SERVICE BULLETIN

N° **189-392**

ATA 50 – BAGGAGE DOORS LATCHES RETROMOD

This Service Bulletin is issued in order to provide the necessary instruction on how to perform the installation of the “Baggage doors latches retromod” P/N 8G5010P00511.

Figure 1

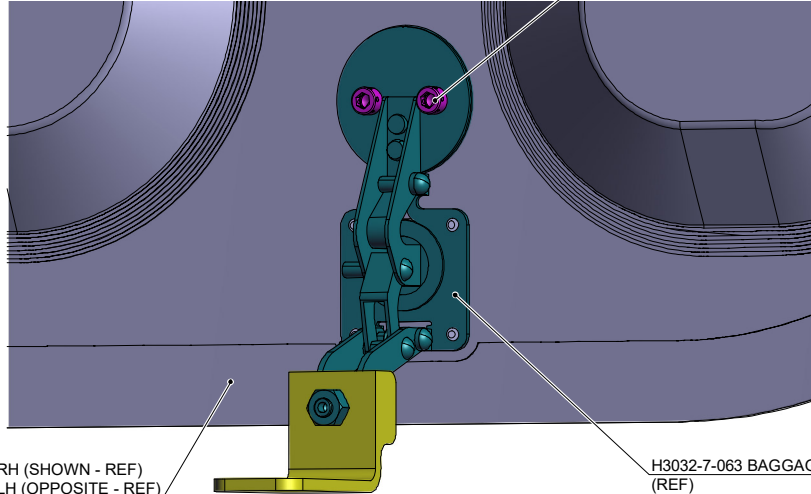
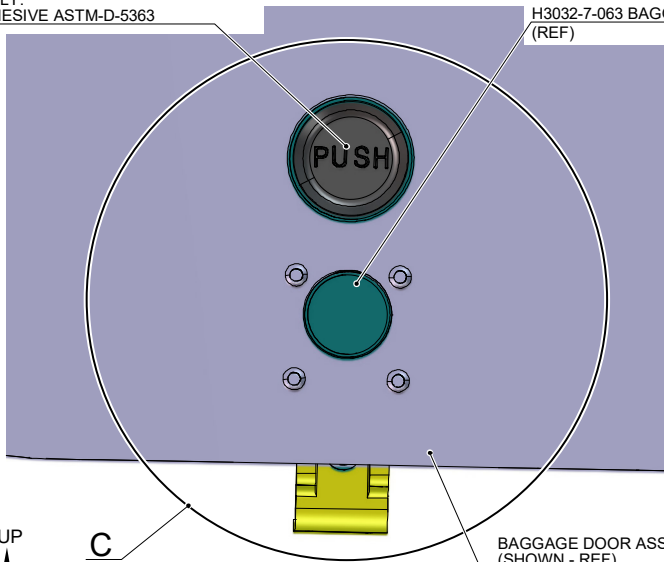
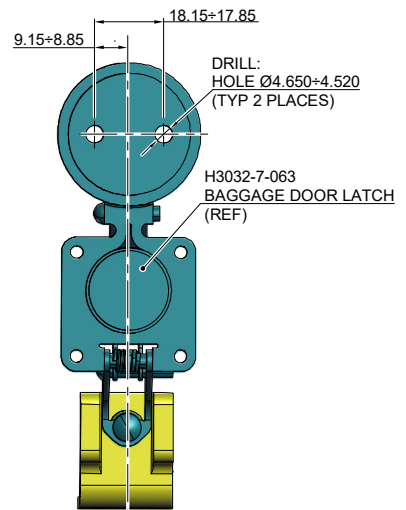
This Service Bulletin is issued in order to provide the necessary instruction on how to perform the installation of the “Baggage doors latches retromod” P/N 8G5010P00511. This retromod introduces two buttons on both of the helicopter’s baggage doors in order to make the opening easier.

3. With reference to Figure 1 Detail C, drill n°2 thru holes $\varnothing 4.52 \div 4.65$ in the indicated positions on the baggage door latch P/N H3032-7-063.

4. With reference to Figure 1 View A and View B, install the shell P/N 8G5010A49451 by means of adhesive LOCTITE 222 (C361) and n°2 screw P/N NAS1352C08-6 on the baggage door latch P/N H3032-7-063.
5. With reference to Figure 1 View B, seal between the baggage door latch P/N 8G5010A49451 and the shell P/N H3032-7-063 using sealant MC-780 Class A (C465).

6. Repeat steps 3 thru 5 to install the shell P/N 8G5010A49451 on the two baggage door latches P/N 8G5010A49451 of each baggage door assy.
7. In accordance with weight and balance changes, update the Chart A (see Rotorcraft Flight Manual, Part II, section 6).
8. Return the helicopter to flight configuration and record for compliance with this Service Bulletin on the helicopter logbook.
9. Gain access to My Communications section on [Leonardo Customer Portal](#) and compile the “Service - Technical Bulletin Application”.
